AGENDA
REGULAR MEETING OF THE
WINDSOR HEIGHTS
PLANNING AND ZONING COMMISSION
Wednesday, February 28, 2024 - 5:30 PM
WINDSOR HEIGHTS COUNCIL CHAMBERS - 1133 66th ST
ZOOM: <https://us02web.zoom.us/j/7832856334>
Meeting ID: 783 285 6334

STAFF REPORT

Date: February 28, 2024
To: Windsor Heights Planning and Zoning Commission
From: Trey Rouse
Subject: Site Plan: 6961 University Avenue (Casey's)

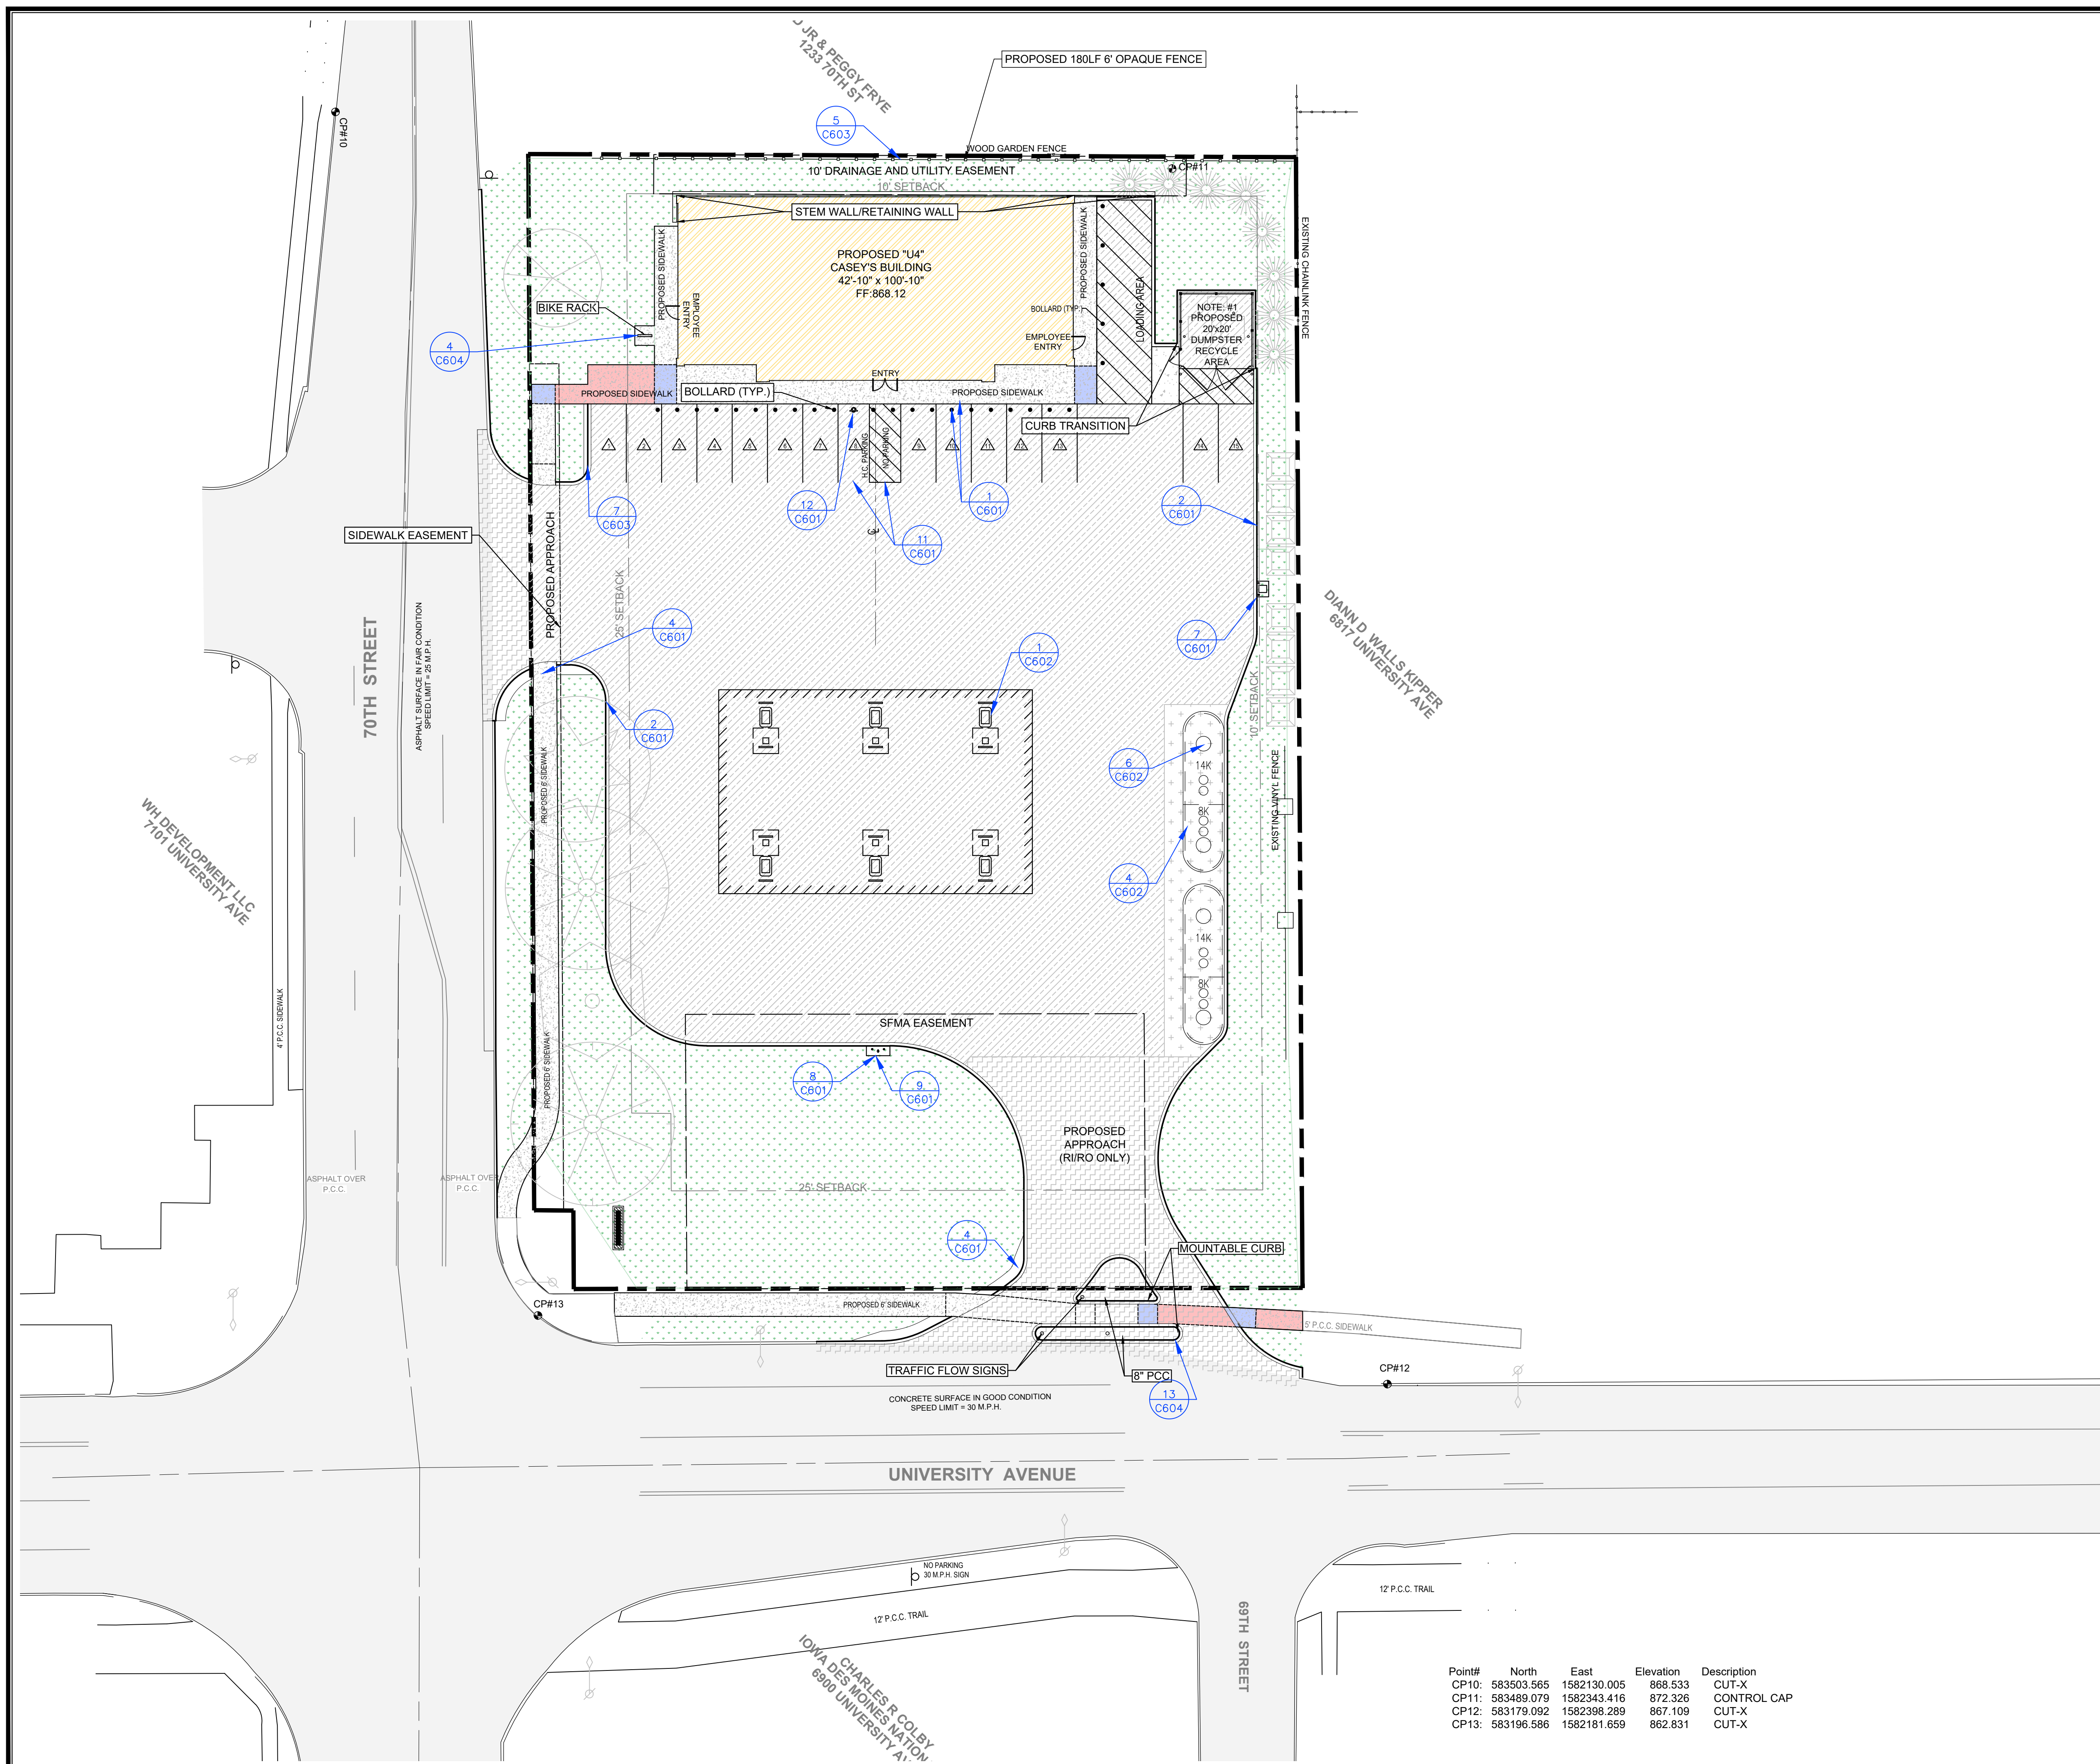
3. Sheet C-100. Where is the water service? Show on plans.

4. Sheet C-100. Note #1, it's in the Urbandale Windsor Heights Sanitary Sewer District, not City of Urbandale/Windsor Heights Sanitary Sewer District.

C-301 - UTILITY SHEET

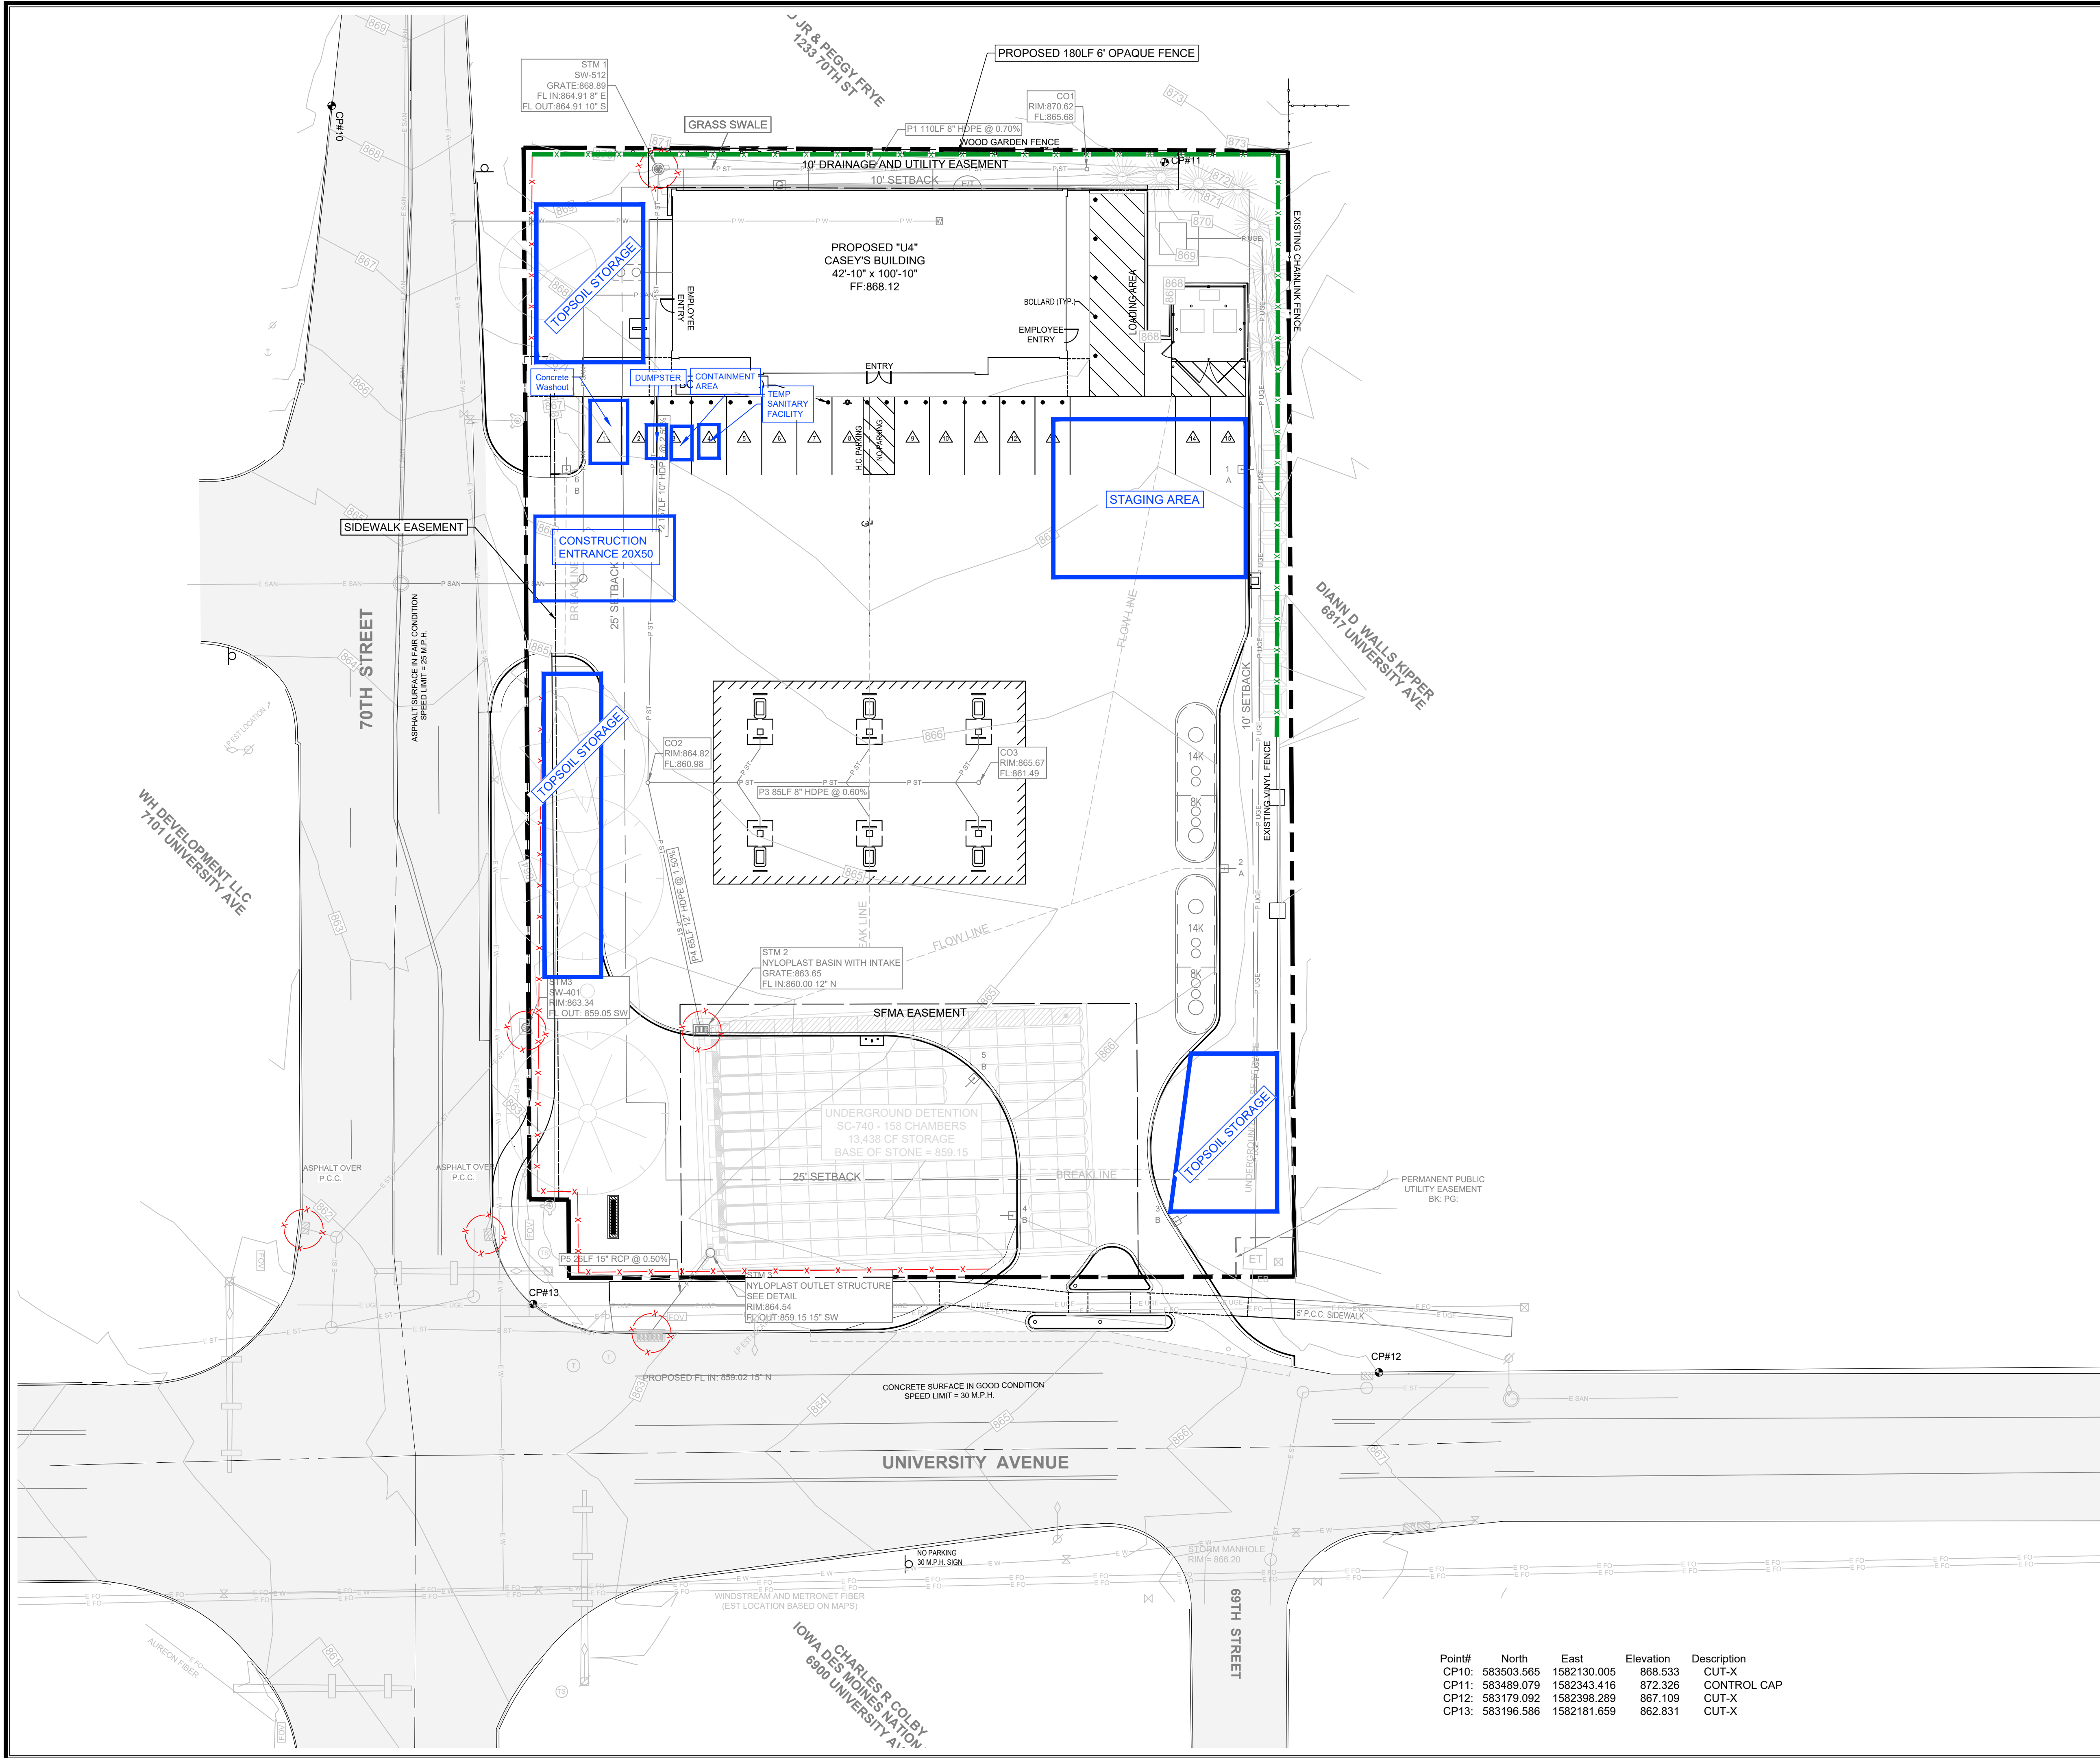
5. Sheet C-301: Sanitary sewer service to be straight within the ROW, no bends.

6. Sheet C-301: Show the new location of the hydrant on 70th Street.

7. Sheet C-301: Show location of water curb stop.

8. Sheet C-301: Cannot see pipe information at swale location.
